Ferrell-Duncan Clinic, Inc.

Subject: NRC License 24-24332-01

As required under NRC CFR 35.14, we have changed our department lay out and are notifying you of those changes of our current areas of use. We are also removing a physician from our list of Authorized Users.

New A

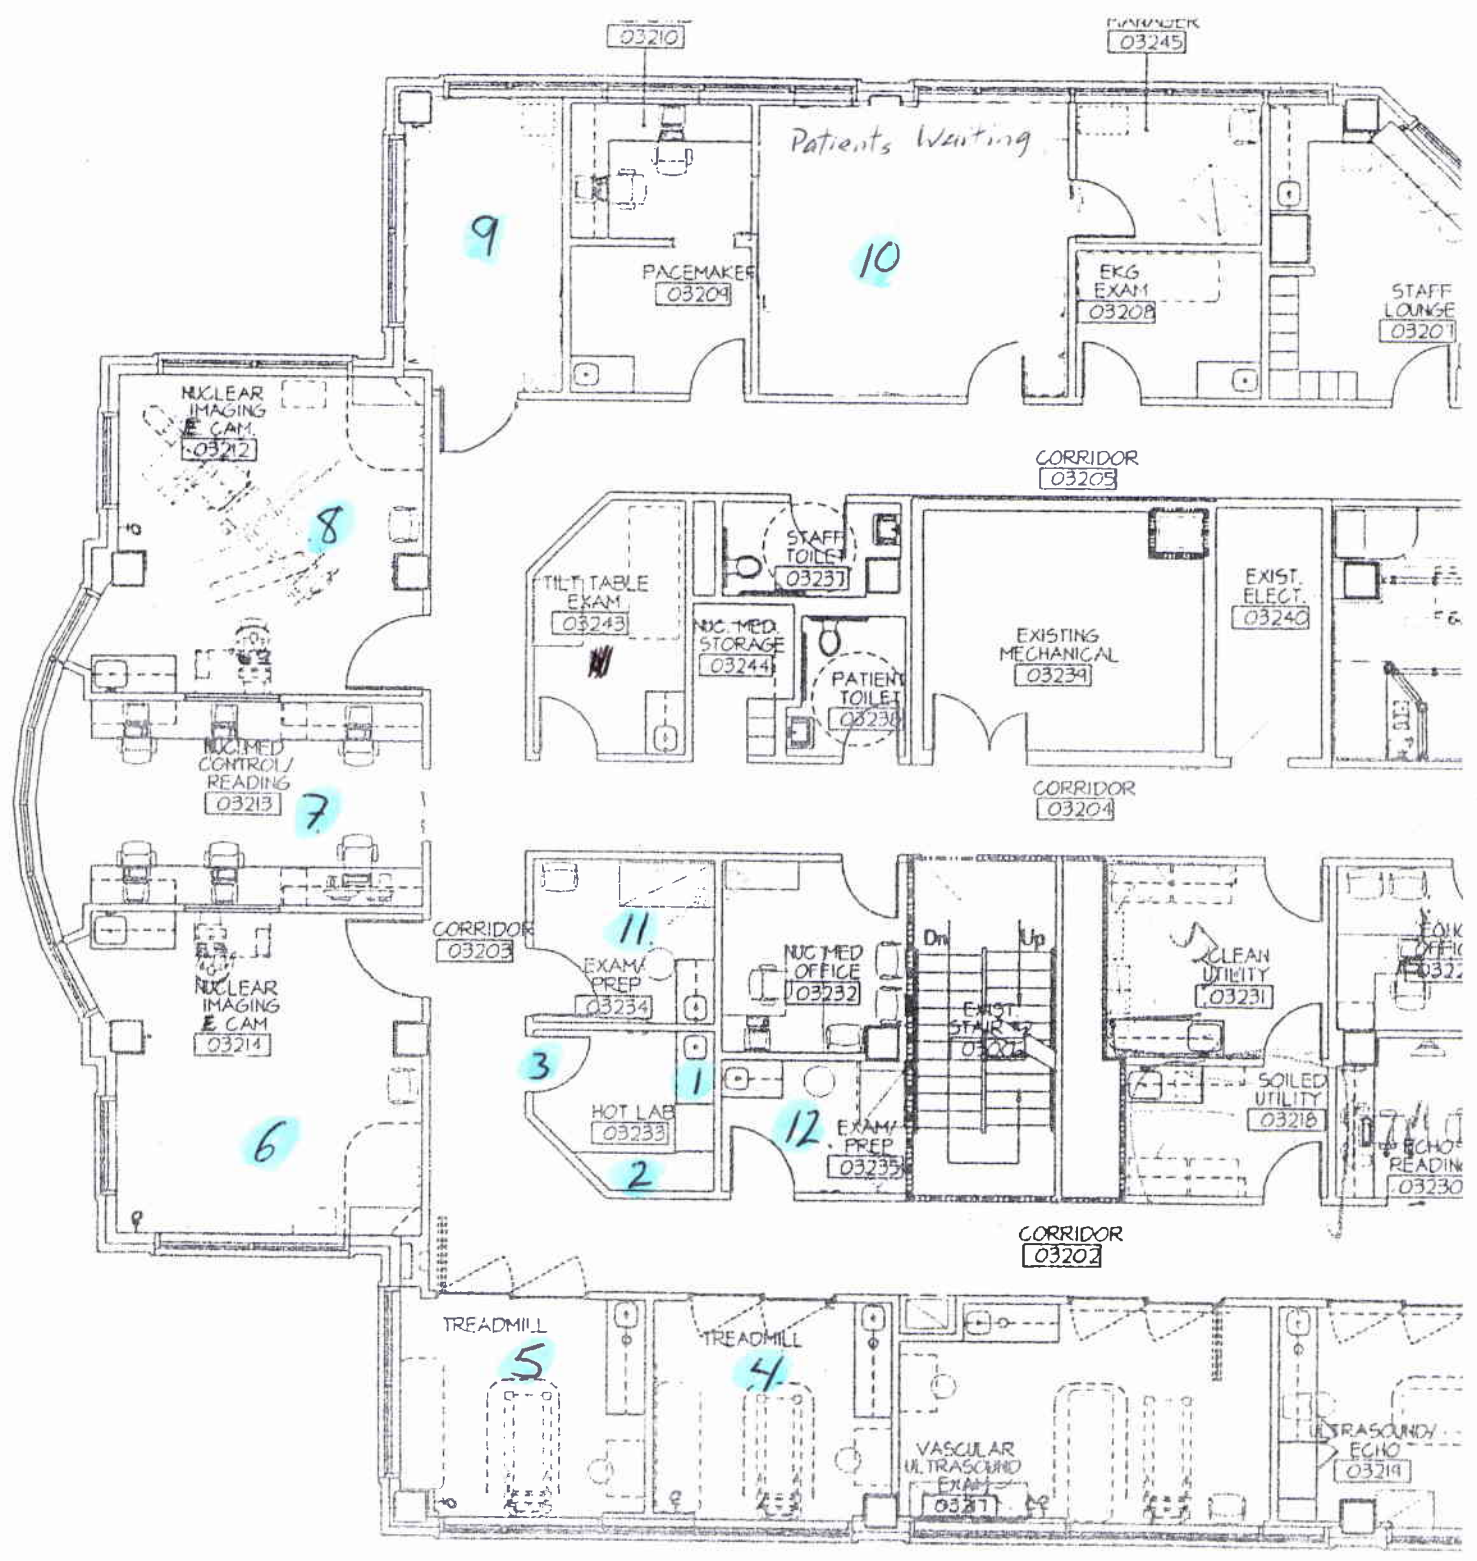
1. The area designated as Room #9 on our site map has become an imaging room. We have purchased a Spectrum Dynamics D-Spect imaging system that we will locate there.
2. The area that is designated as Room 10, we request to be removed from our license as an area of use. (We have never actually used by-product materials in area 10 but have maintained it under our license to allow for future growth.)
3. As is displayed on the new map enclosed, we have designated the new nuclear medicine waiting area as Room 10. We will continue to survey and complete the appropriate wipe testing as required under our license for all areas of use.
4. Please remove Bruce Hedgepeth, M.D. from our list of Authorized Users.
